SERVICE BULLETIN

NUMBER: 02-166-17R

SUBJECT: Upper Oil Pan Assembly- Design Changes

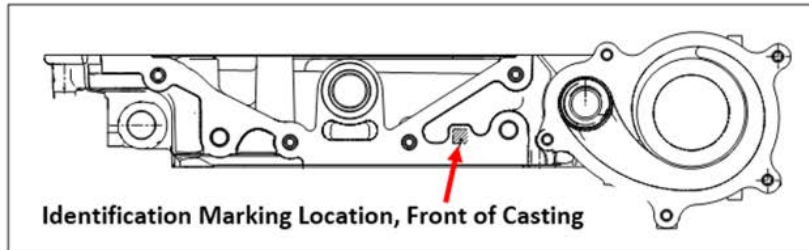
- The mating flange thickness of the casting in the area identified as the cause for the seepage has been increased by 5.5mm. (See images provided in the Parts Information section below.) This thickness increase creates the need for a longer bolt to provide proper tightening and retention.
- An additional mounting point has been added to the ribbing inside the casting to increase retention of the steel baffle plate and eliminate vibration.

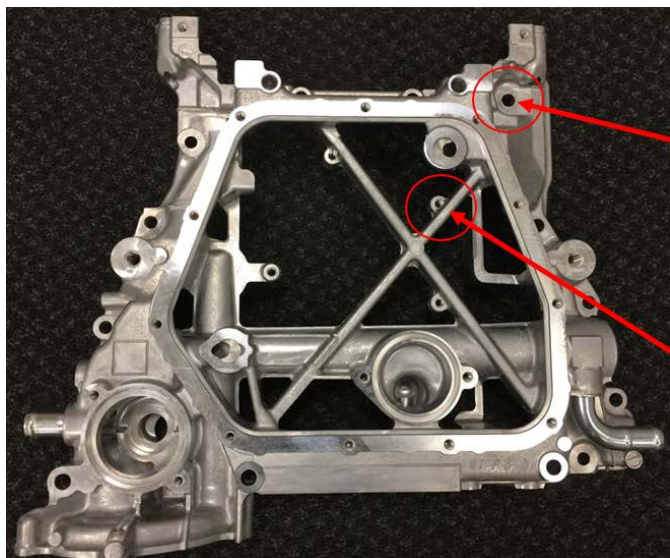
- An underscore has been added to the identification letter found on the front face next to the water pump cavity and QR code box.

- Thicker casting and an additional mounting point for the baffle plate added to the internal ribbing.

Because the thickness of the casting has been increased by 5.5mm in this area, a new, longer socket-head cap screw, p.n. 800408250 is required replacing the original hex head bolt.

An additional mounting point / bolt hole has been incorporated here to improve retention of the baffle plate. Use hex bolt p.n. 808206010.
